Date: Monday 2 May 2022
Time: 9.30am
Venue: Online via Microsoft Teams

HEARING REPORT
NOTICE OF REQUIREMENT
WHANGAPOURI ROAD SUBSTATION
COUNTIES ENERGY

Pursuant to section 168 of the RMA, Counties Energy as the requiring authority, has lodged a notice of requirement (NoR) for a designation for the Whangapouri Road Substation in the Auckland Unitary Plan (Operative in part) (AUP) at 8 Whangapouri Road, Karaka.

Figure 2: Schematic illustration of visual dominance effects by the applicant from the submitter's site

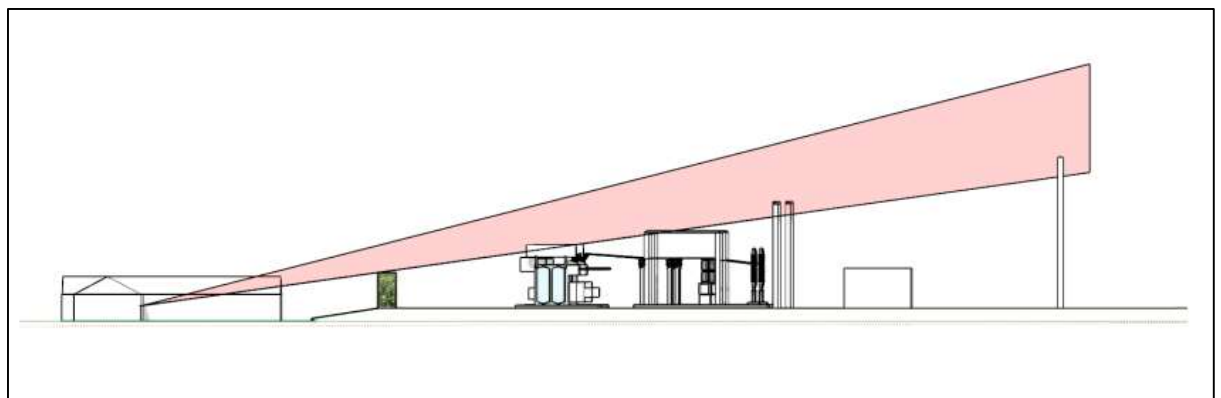
- The schematic cross section illustrated in the Section 92 response only considers the effects from one viewpoint – from the front door of 14 Whangapouri Road. It does not consider adverse effects from outside the dwelling. The submitter states it is expected that their property will be used for outdoor and recreational activities and believe the substation could impose “significant visual dominance effects”.

- 2.5. Further, the schematic cross section illustrated in the s92 Response had considered the viewpoint from the entrance of the submitter's dwelling. The viewpoint may have noted that the substation could impose considerable visual dominance effects if it had been taken from the adjoining southern boundary of the submitter's site. It is expected that the residents will be using the southern boundary of the submitter's site for any outdoor or recreational activities and a substation could impose significant visual dominance effects. The proposed hedge buffer may not offer adequate visual effects mitigation in this case.
